### TR010060 - A12 Chelmsford to A120 Widening Scheme - Gershwin Boulevard Bridge

In reviewing the numerous documents released in relation to Deadline 3, one of these is document reference **TR010060/EXAM/9.26 - TECHNICAL NOTE GERSHWIN BOULEVARD BRIDGE**. It is clear that National Highways and/or their contractors have had the opportunity to review my submissions and those of several of my neighbours in relation to the proposed bridge located adjacent to Olivers Drive and Halfacres in Witham, in order to produce this extensive document. It is only fair that I, and others if they wish to do so, have the opportunity to respond to this technical note, which I believe to be significantly flawed.

Image 3 - captured from Essex County Council Interactive PRoW map. Added indicators show approximate position and direction of images 1 and 2.

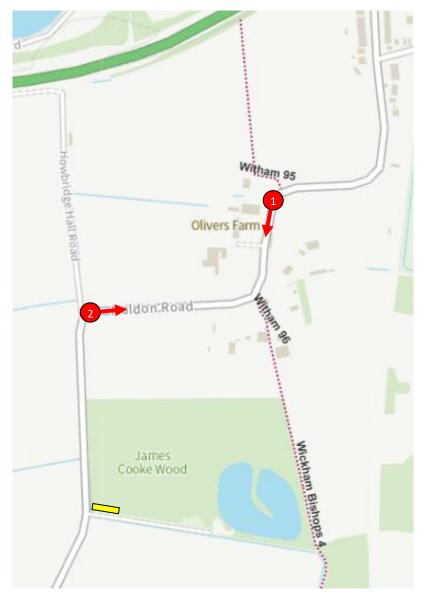
James Cooke Wood is a publicly owned space managed by Witham Town Council for the benefit of the people of Witham. Although footpath 268\_4 bounds this, there is no current access. The only practical means to access this is by car, parking on a parking area on the track to the South of the wood (indicated by a yellow rectangle). The lake indicated is a privately owned fishing lake and not part of the wood.

The land between the wood and Maldon Road is part of the Olivers Nursery complex. Footpath 121\_96 crosses this land.

A new piece of information is that the owner of Olivers Nursery has agreed that if footpath 121\_95 is diverted onto Howbridge Hall Road, he would be prepared to grant Permissive Access along the Western Boundary of his land to provide access to James Cooke Wood.

As well as allowing increased use of the wood, this would enable an alternative link to footpath 268\_4.
